UNITED STATES PATENT AND TRADEMARK OFFICE

APPLICATION NO.	FILING DATE	FIRST NAMED INVENTOR	ATTORNEY DOCKET NO.	CONFIRMATION NO.
10/624,649	07/23/2003	Robert R. Ricci	FS-00790	6899
7055	7590	10/21/2005		
GREENBLUM & BERNSTEIN, P.L.C. 1950 ROLAND CLARKE PLACE RESTON, VA 20191			EXAMINER HESS, DOUGLAS A	
			ART UNIT	PAPER NUMBER
			3651	
DATE MAILED: 10/21/2005

DETAILED ACTION

FIG. 2

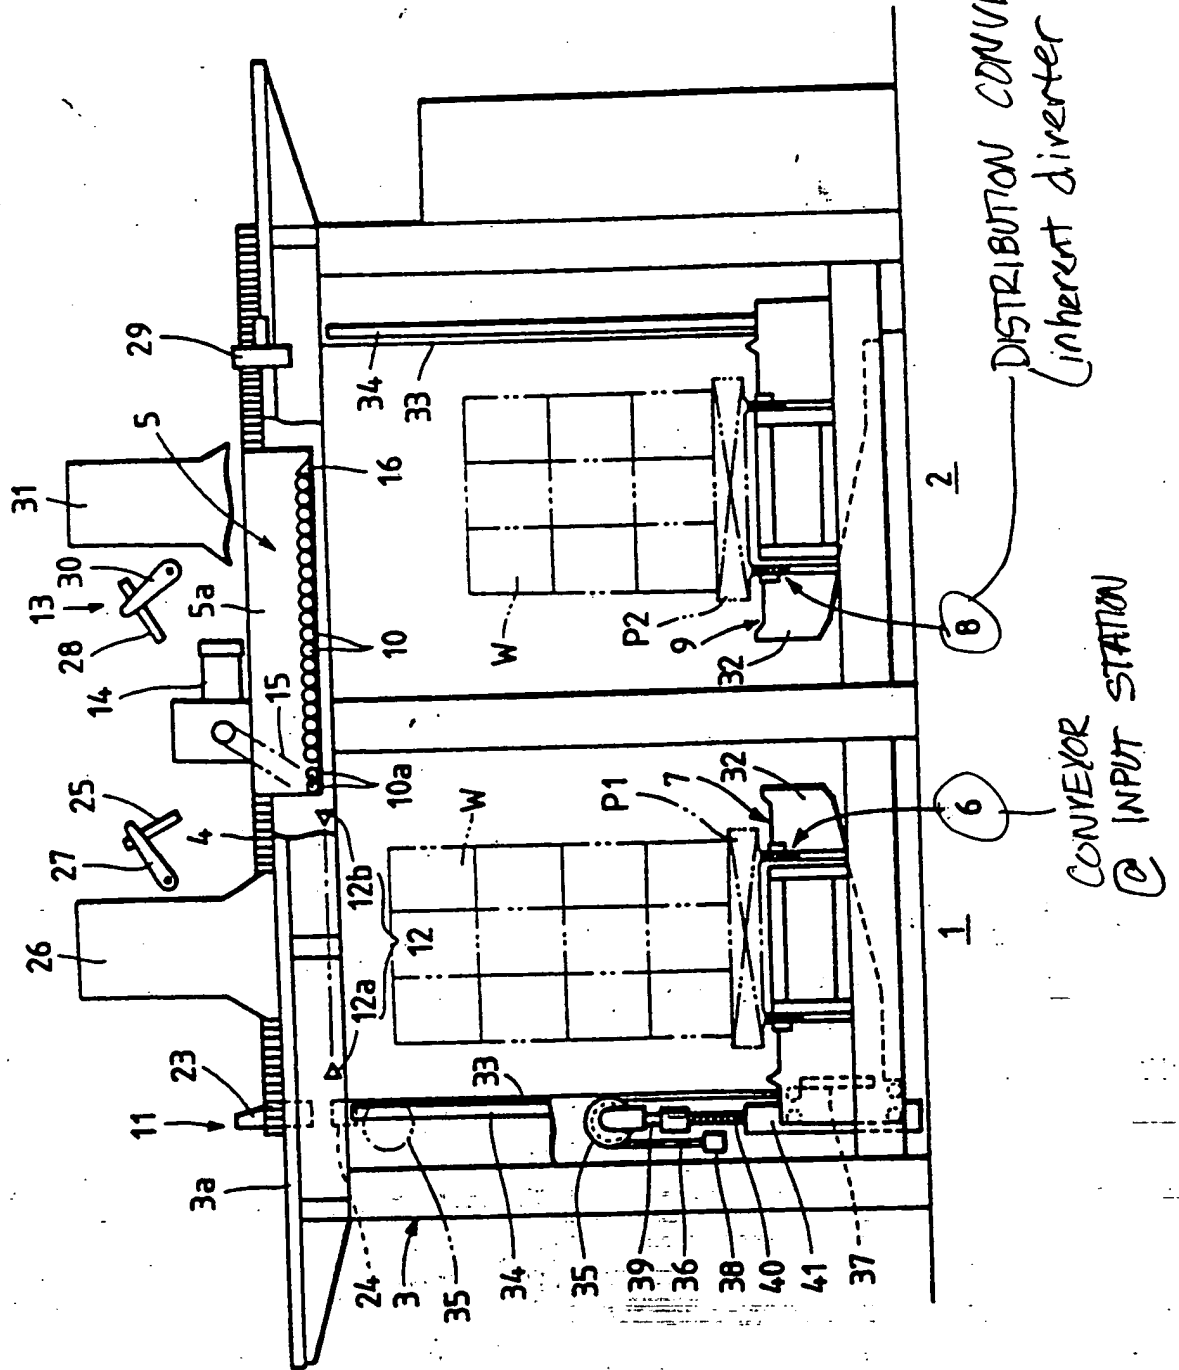
See the attached marked up drawing sheets: 2 of 6, 4 of 6, and 5 of 6 of Hasegawa depicting the claimed features.

FIG. 4a

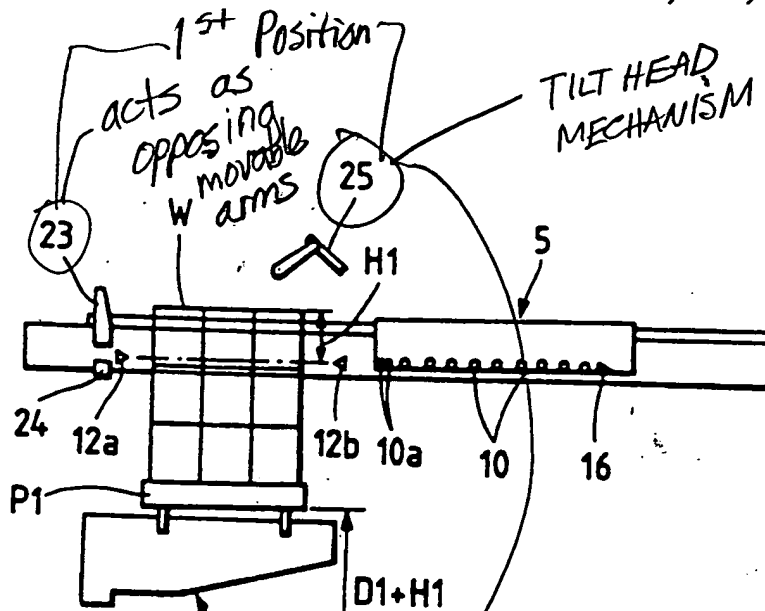
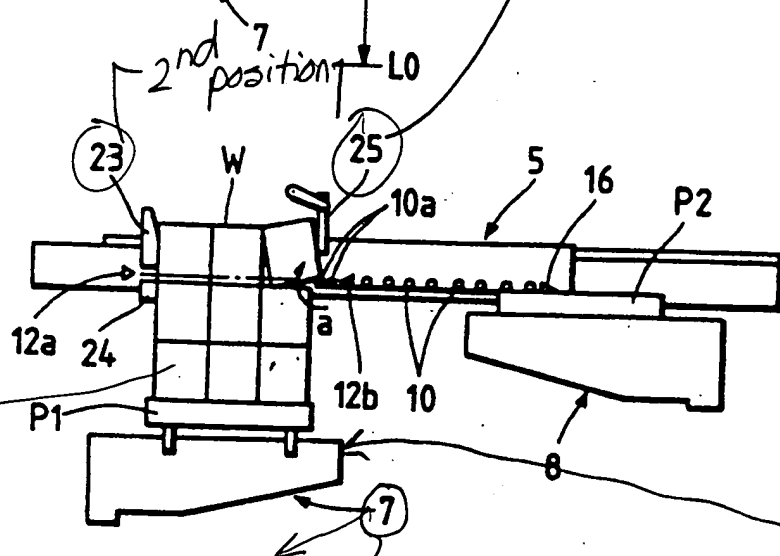
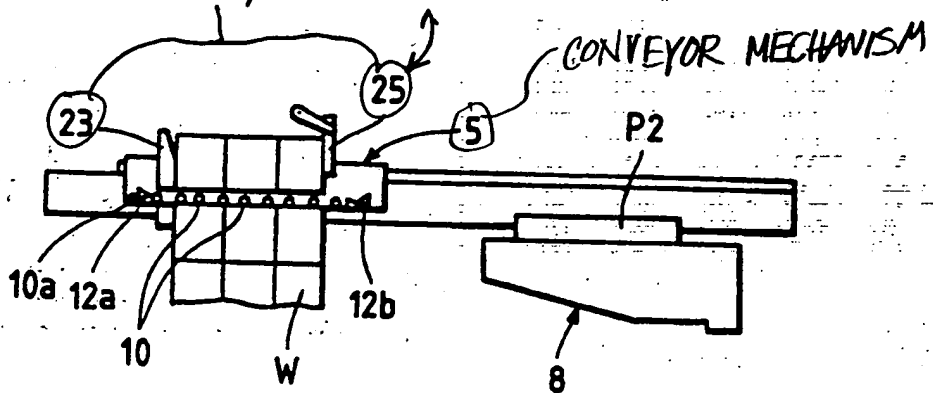
constructed as
mail objects
and flats as claimed

LIFTING DEVICE w PLATFORM

HEAD/HOING DEVICE (opposing movable arms)

FIG. 5

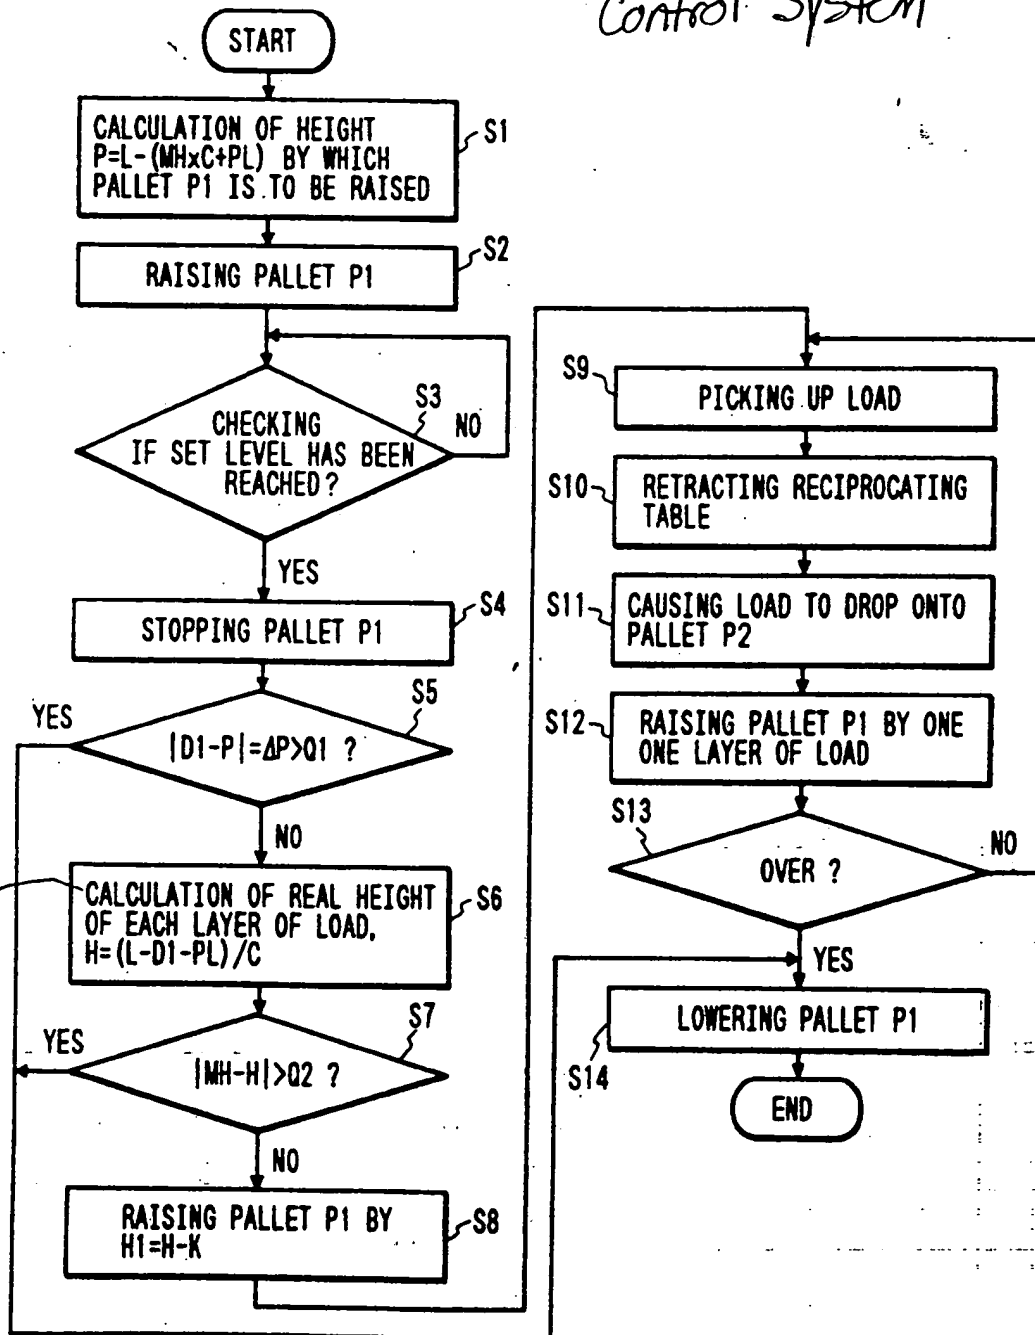
Control System

Determines HEIGHT
